AMERICAN SOCIETY
OF
CIVIL ENGINEERS

DISCUSSION
OF PROCEEDINGS - SEPARATES

DISCUSSION OF A DIRECT STEP METHOD FOR COMPUTING WATER-SURFACE PROFILES PROCEEDINGS—SEPARATE 180

**DISCUSSION OF DAM MODIFICATIONS
CHECKED BY HYDRAULIC MODELS
PROCEEDINGS-SEPARATE 184**

FIG. 4.—ELEVATION—($A R^4$) CURVES

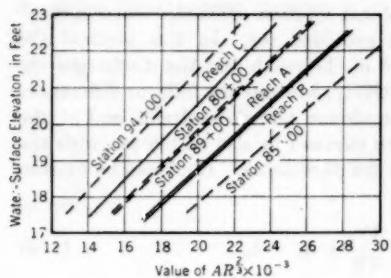
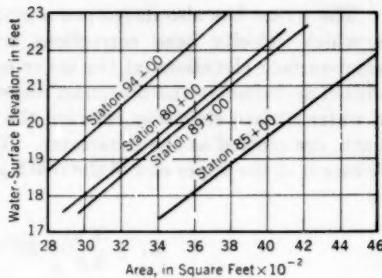
area curves, based on Table 7, are shown in Figs. 4 and 5. Table 8 illustrates the computations for reach A (station 80 + 00 to station 85 + 00). The values of $A R^{\frac{1}{2}}$ (Col. 5) and areas (Cols. 6 and 7) were obtained from the curves in Figs. 4 and 5. The resulting slope curves are shown in Fig. 6. The curves for reaches B (station 85 + 00 to station 89 + 00) and C (station 89 + 00 to station 94 + 00) are shown in Figs. 7 and 8.

FIG. 9.—CURVES FOR COMPUTING WATER-SURFACE PROFILE

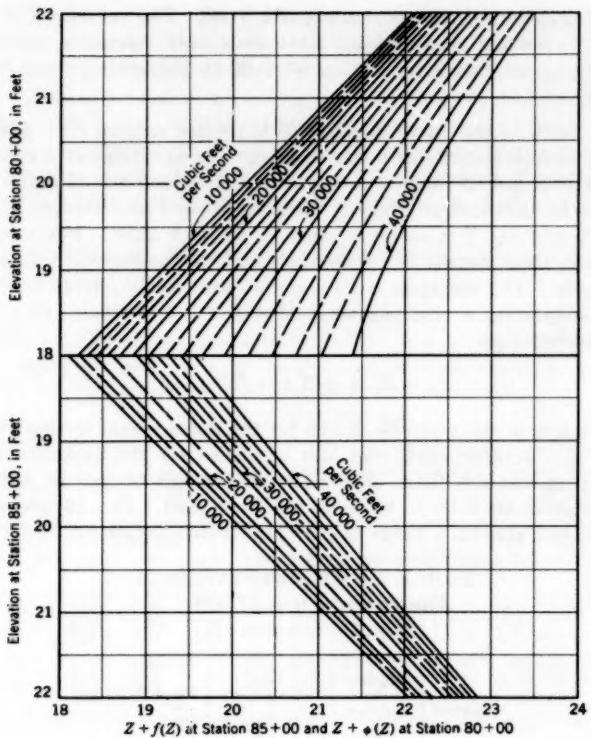
Alternate Plotting Procedures.—Adaptation to specific needs as well as to individual preference determines the most convenient method of plotting. For example, if curves were to be prepared which would be suited to a wide variety of flows, the form used by the author would become unwieldy. It would seem logical, therefore, to use one plotting sheet for each reach, showing on each a family of discharge curves. An example for the reach from station 80 + 00 to station 85 + 00 is shown in Fig. 9 which was prepared from Table 12. Values of $\phi(Z)$ and $f(Z)$ in Table 12 for the various flows were computed from the base value for 33,500 cu ft per sec, using the ratio of the discharges squared, as suggested by Mr. Ezra. The solid lines in Fig. 9 were drawn from computed values of $Z + \phi(Z)$ and $Z + f(Z)$. The dashed intermediate lines were interpolated by use of construction lines based on the computed curves. The form of this plot differs from that presented by the author. In this form, if eddy losses are ignored, the upper curves can be entered with the known elevation at the downstream section and flow—for example, El. 20.32 at station 80 + 00 and 37,000 cu ft per sec. This intersection is carried vertically downward to the lower curves until the proper discharge is reached. This lower intersection

gives a resulting elevation of 21.28 at station 85 + 00. The values of $Z + \phi(Z)$ and $Z + f(Z)$ need not be tabulated since they only represent guide lines connecting the upper curves for station 80 + 00 to the lower curves for station 85 + 00.

Mr. Buehler has made a valuable contribution to the method of computing water-surface profiles. His suggestions for alternate plotting procedures are very appropriate. It is agreed that one plotting sheet should be used for each reach, as shown in Fig. 9. The form used in Fig. 2 was presented for the purpose of illustrating the application of the proposed method. The method of plotting shown in Fig. 10 is an ingenious solution to the practical difficulty involved in plotting a graph to cover a range of 50 ft in elevation at a section. It has been found that the method of inclusion of overbank flow, proposed in Eqs. 23 and Table 11, is a commonly used expedient. Basically, this method corresponds to the use of the function,¹¹

FIG. 10.—CURVES OF $\phi(Z)$ AND $f(Z)$ FOR COMPUTING WATER-SURFACE PROFILES

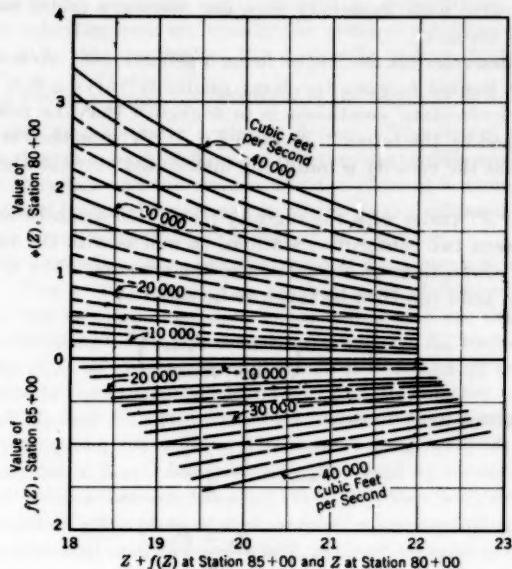
For any reach, a curve can be drawn for the downstream section showing $\phi(Z)$ versus Z . Another curve can also be drawn for the upstream section showing $f(Z)$ against $Z + f(Z)$. Fig. 10 is an example of this in which the reach from station 80 + 00 to 85 + 00 has been used. Fig. 10 was plotted from the data in Table 12. Table 13 shows the water-surface profile for a flow

of 37,000 cu ft per sec and illustrates the use of the curves. Starting with El. 20.32 or Z at station 85 + 00, $\phi(Z)$ (Col. 3, Table 12) is found to be 1.78 from the upper curves. This value is added to Z to get a value of $Z + \phi(Z)$ equal to 22.10 (Col. 4, Table 13). From Eq. 4, however, this value equals $Z + f(Z)$ at station 85 + 00. Entering with this value of 22.10 in the lower curves, $f(Z_1)$ (Col. 5, Table 13), is found to be 0.82. The value of Z at station 85 + 00 (El. 21.28) is Col. 5, Table 13, subtracted from Col. 4, Table 13. In this procedure, elevations are not read from the curves. Instead, factors comprising the difference in elevations are read. The operation requires more tabulating than when Fig. 9 is used; but with the same size graph paper, it is far more accurate whenever wide elevation ranges must be accommodated. Of course, it is presumed that reaches will be short enough so that values of $\phi(Z)$ and $f(Z)$ will be sufficiently small to plot with reasonable accuracy.
